Ref: C2PCPX for FCC ID: VN5-CPB

Applicant: Ascensia Diabetes Care US Inc.

This letter is to request a C2PCPX change to implement the following proposed updates to the hardware of the device:

Figure 1: Area of PCB Impacted by Change

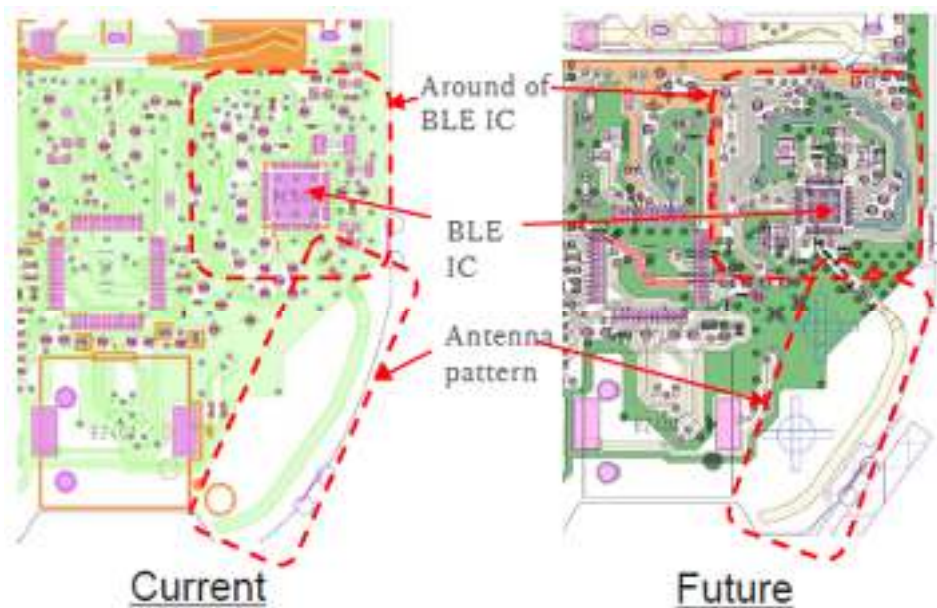
In conjunction with the IC replacement, supporting peripheral components will be updated. This will result in a minor board layout update to accommodate the new BLE IC. The functionality of the RFE block remains unchanged and is not impacted by these modifications.

Figure 2: RFE Block of Toshiba BLE IC (current)

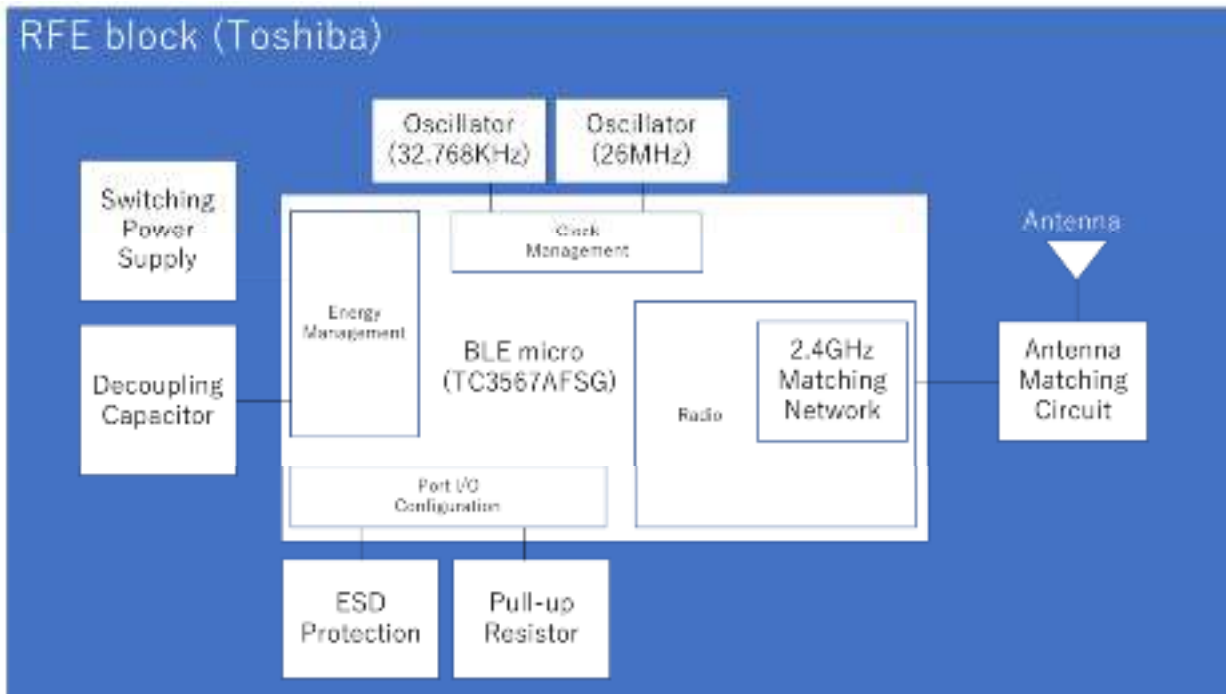
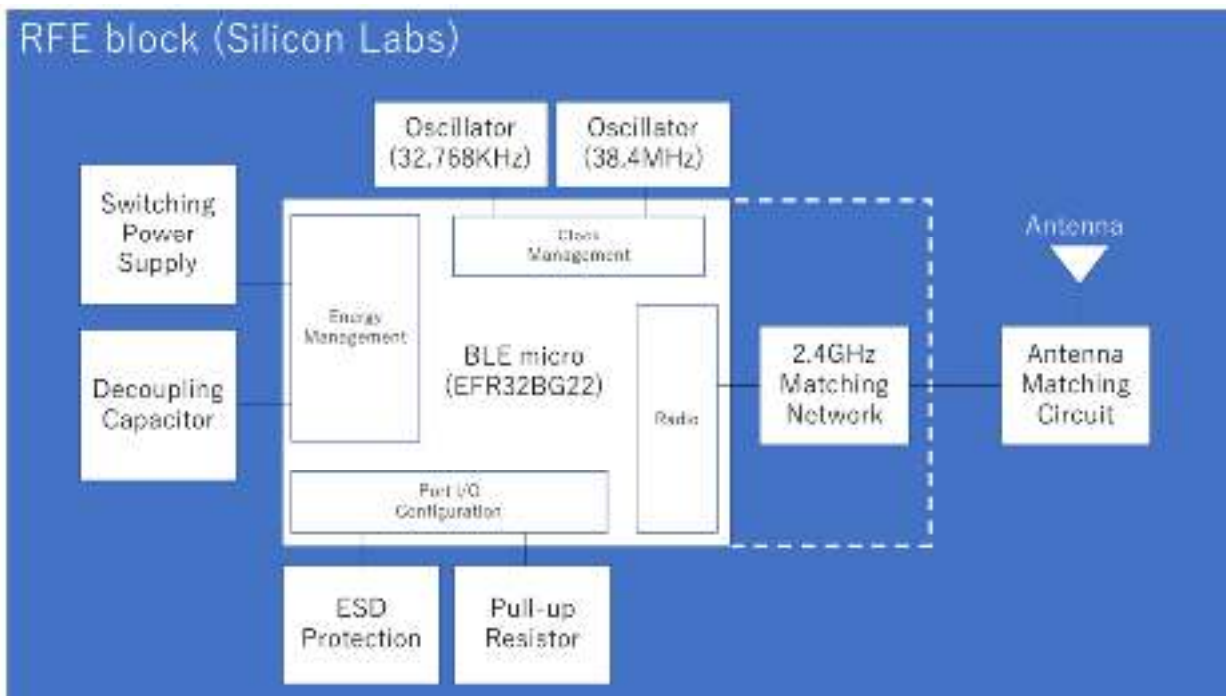
The currently approved Toshiba BLE IC (as part of VN5-CPB) is reaching end-of-life and will be replaced by the proposed Silicon Labs BLE IC.
